The Commission has issued the enclosed Amendment No. 37 to Facility Operating License No. DPR-66 for the Beaver Valley Nuclear Power Station, Unit No. 1. The amendment consists of changes to the Technical Specifications in response to your application transmitted by letter dated November 17, 1977.

Amendment No. 37
License No. DPR-66

AMENDMENT NO. 37 TO FACILITY OPERATING LICENSE NO. DPR-66

SAFETY EVALUATION BY THE OFFICE OF NUCLEAR REACTOR REGULATION
RELATED TO AMENDMENT NO. 37 TO FACILITY OPERATING LICENSE NO. DPR-66

FIGURE 3.6-1 MAXIMUM ALLOWABLE PRIMARY CONTAINMENT AIR PRESSURE VERSUS RIVER WATER TEMPERATURE AND RWST WATER TEMPERATURE

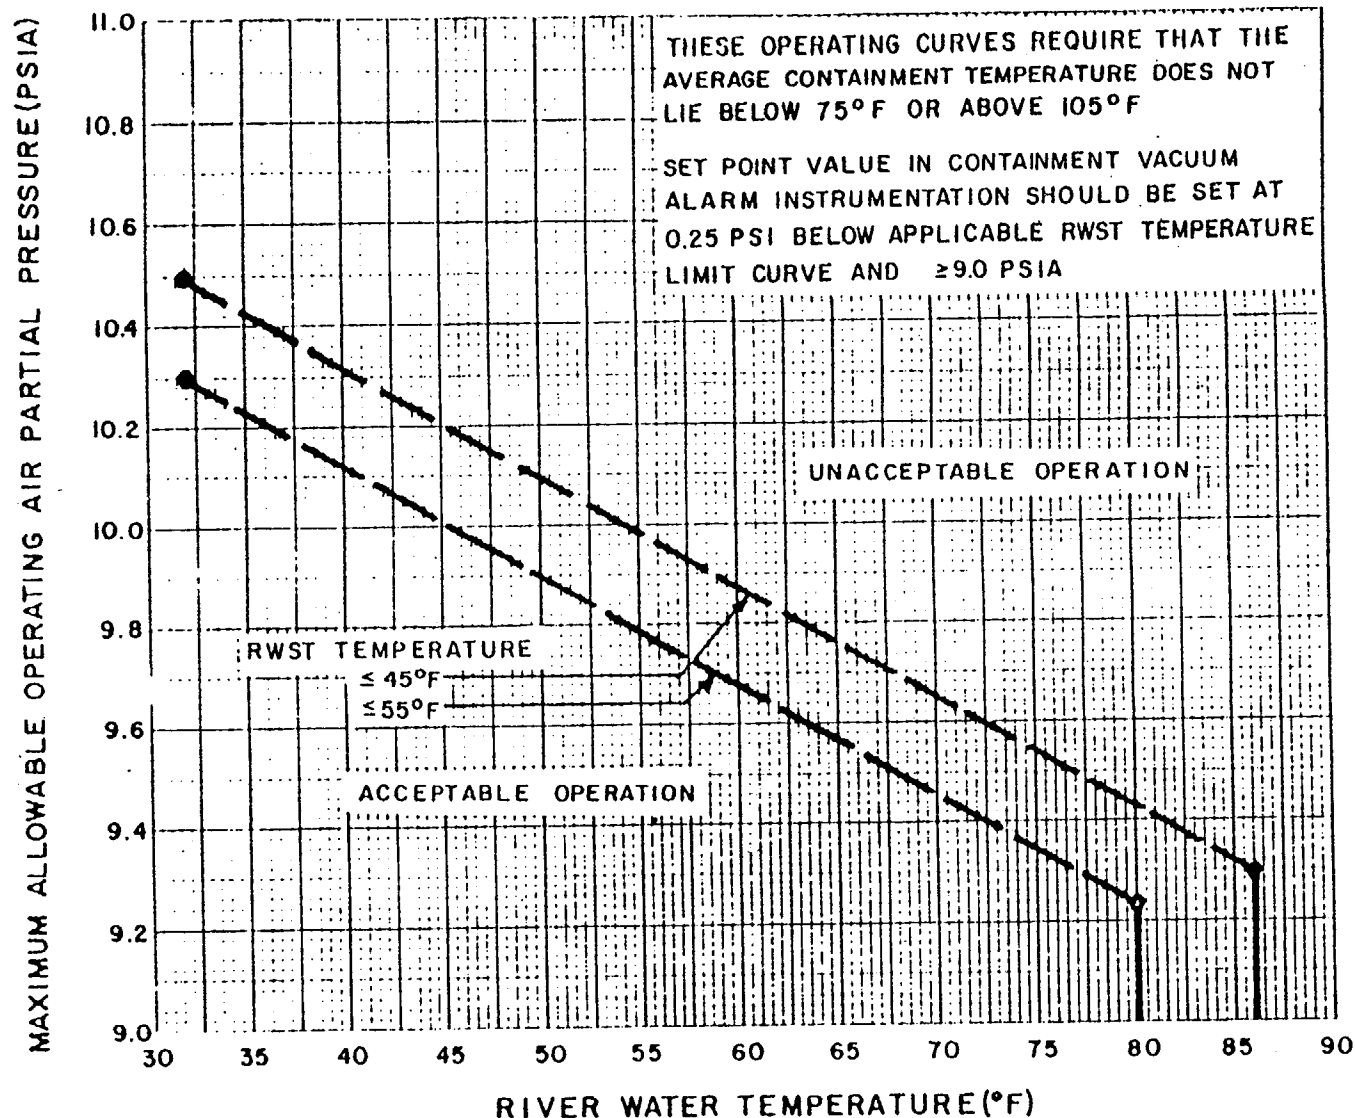
The amendment revises Technical Specification Figures 3.6-1, 3.6-2, and Limiting Condition for Operation statement 3.6.1.5. These changes involve limiting conditions for containment pressure and temperature and the limiting temperature for both the river water and the RWST water during normal operation.

Along with the hardware modifications, the licensee proposed changes to Technical Specification Figures 3.6-1 (Maximum Allowable Primary Containment Air Pressure versus River Water Temperature and RWST Water Temperature), 3.6-2 (Minimum Allowable Primary Containment Average Air Temperature versus River Water Temperature), and Limited Condition for Operation statement 3.6.1.5.

The revised Technical Specifications tend to increase the minimum vapor temperature and decrease the maximum partial pressure due to air for lower river water temperatures. These two effects tend to cancel out. In addition, for higher river water temperatures, the revised Technical Specifications tend to decrease the minimum vapor temperature and increase the partial pressure due to air. Again, these two effects tend to cancel each other. Plugging nozzles in the spray header, however, tends to decrease the containment heat removal rate which increases both the peak calculated containment pressure and the containment depressurization time (subatmospheric containments are required to depressurize and return to subatmospheric conditions within one hour following a design basis accident).

The technical specification for Initial Average Containment Temperature has been incorporated into 3.6.1.5 (Page 3.6-8) and Figure 3.6-1 (Page 3.6-7).
